DATE: 7/2/2004

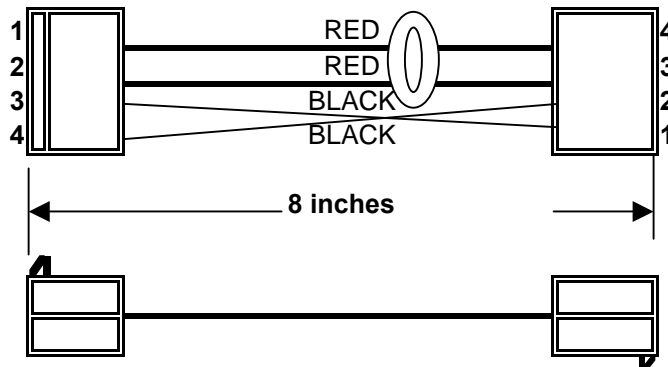
A: 2006-04 White Color

B: Wire length change from 7" to 8"

1. Wire: 22AWG, 105C, 600V, UL, CSA
2. Ferrite: OD:12.8mm, 7.67mm, height: 6.42mm  
(Ferrite - accept our suggestion, as long as closer size).
3. Red wire 1 circle with ferrite as above indicated.
4. Completed wireharness as following image:
- 5. Twist wire tight.**
